05PD063

SITE LAYOUT PLAN
NOT TO SCALE
AC19-1
RECEIVED
OCT 05 2005
Rapid City Growth Management Department
MAJOR AMENDMENT TO PCD PLAN
THE PARKING LOT LAYOUT HAS SHIFTED SLIGHTLY TO TAKE ADVANTAGE OF THE ADDITIONAL PROPERTY GAINED RIGHT VACATING A PORTION OF ELEVENTH STREET ROW.
THE TOTAL NUMBER OF PARKING SPACES REMAINS UNCHANGED FROM THE 226 SPACES PREVIOUSLY APPROVED.
LANDSCAPE ISLANDS IN THE SOUTHEAST CORNER OF THE LOT HAVE SHIFTED TO MEET THE REVISED PARKING LOT LAYOUT. ALL PLANTING AND VEGETATION REMAIN THE SAME.
SITE LIGHTING REQUIREMENTS AND DESIGN HAVE NOT CHANGED
PUBLIC SIDEWALK CHANGES ARE REQUIRED DUE TO VARIOUS CONFLICTS WITH UTILITY INFRASTRUCTURE
PARKING LOT CURB, GUTTER AND PAVEMENT ARE DESIGNED INTO AREA THAT WAS RECENTLY VACATED ROW.
5'-0" SIDEWALK ADJACENT TO STREET CURB ALONG ELEVENTH AND RAPID STREET
ALTERNATE TO ITEM 2 ABOVE: 5' STREET SIDEWALK IS NOT APPROVED. THEN WE REQUEST A MODIFIED LOCATION FOR THE ELEVENTH STREET SIDEWALK AS FOLLOWS:

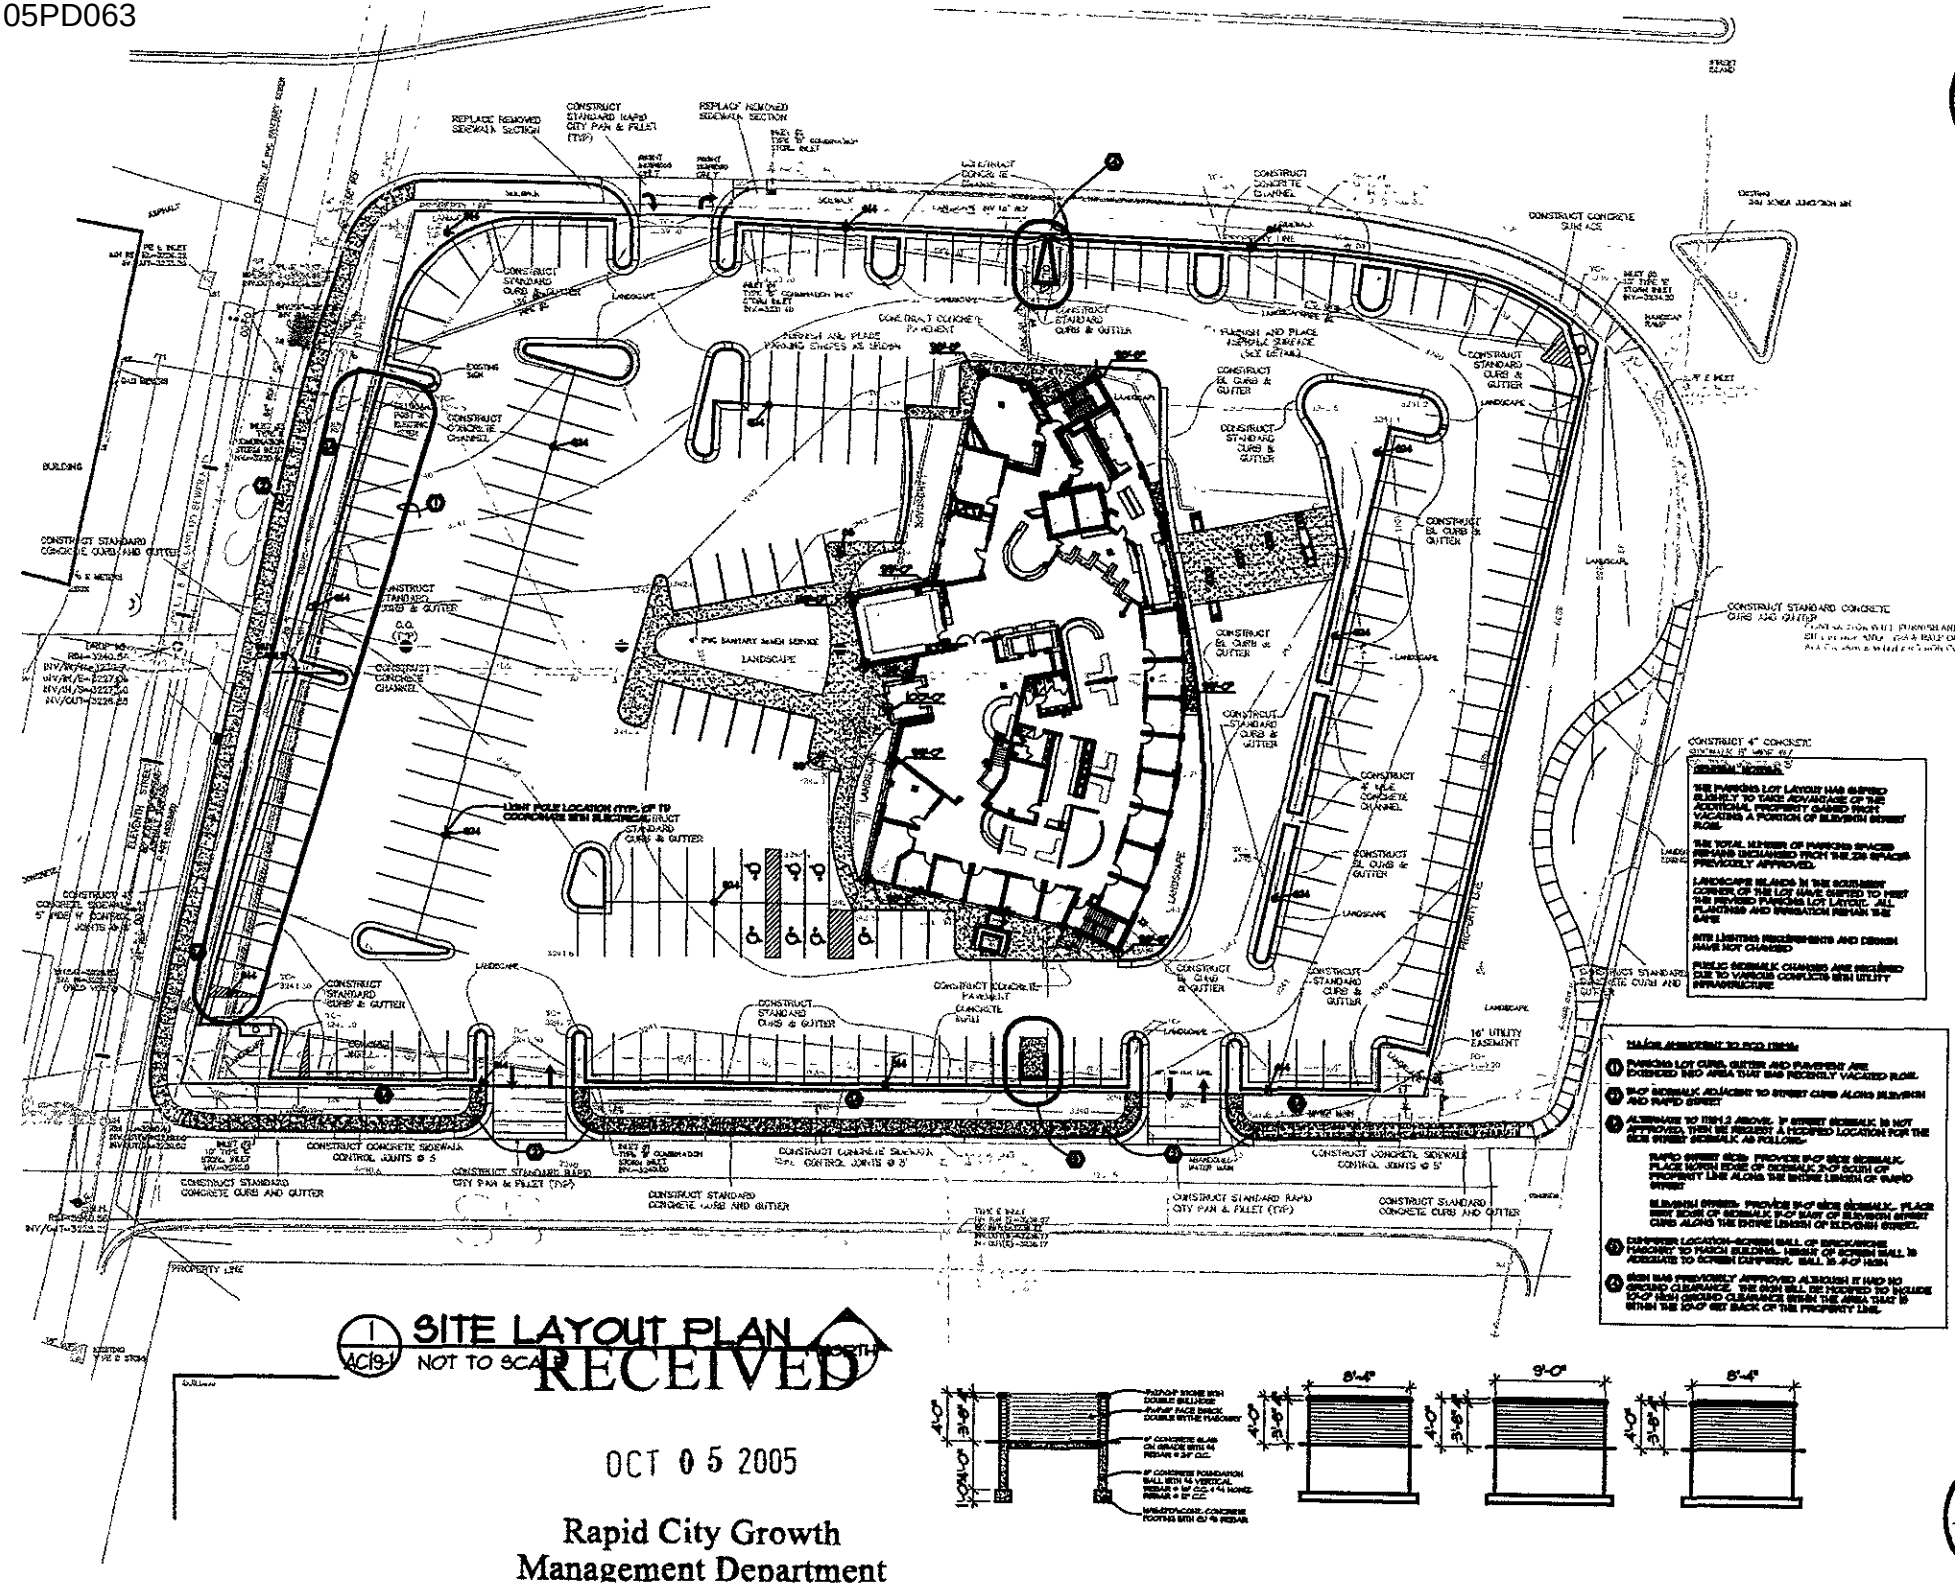
RAPID STREET SIDE: PROVIDE 5'-0" WIDE SIDEWALK. PLACE WITH EDGE OF SIDEWALK 2'-0" SOUTH OF PROPERTY LINE ALONG THE ENTIRE LENGTH OF RAPID STREET
ELEVENTH STREET: PROVIDE 5'-0" WIDE SIDEWALK. PLACE WITH EDGE OF SIDEWALK 2'-0" EAST OF ELEVENTH STREET CURB ALONG THE ENTIRE LENGTH OF ELEVENTH STREET.
DUMPSTER LOCATION-SCREEN WALL OF BRICK/WOOD MASONRY TO MATCH BUILDING. HEIGHT OF SCREEN WALL IS ADEQUATE TO SCREEN DUMPSTER. WALL IS 6'-0" HIGH
SIGN WAS PREVIOUSLY APPROVED ALTHOUGH IT HAD NO GROUND CLEARANCE. THE SIGN WILL BE MODIFIED TO INCLUDE 10'-0" HIGH GROUND CLEARANCE WHEN THE AREA THAT IS WITHIN THE 10'-0" REC BACK OF THE PROPERTY LINE.
ARC International inc
1825 Clark Street Suite 101
Rapid City, South Dakota 57702
First Western Gateway
Rapid City, South Dakota
Site Plan
PROJECT NO 2003-038
DATE 9/30/05
DRAWN BY RT
AC19-1
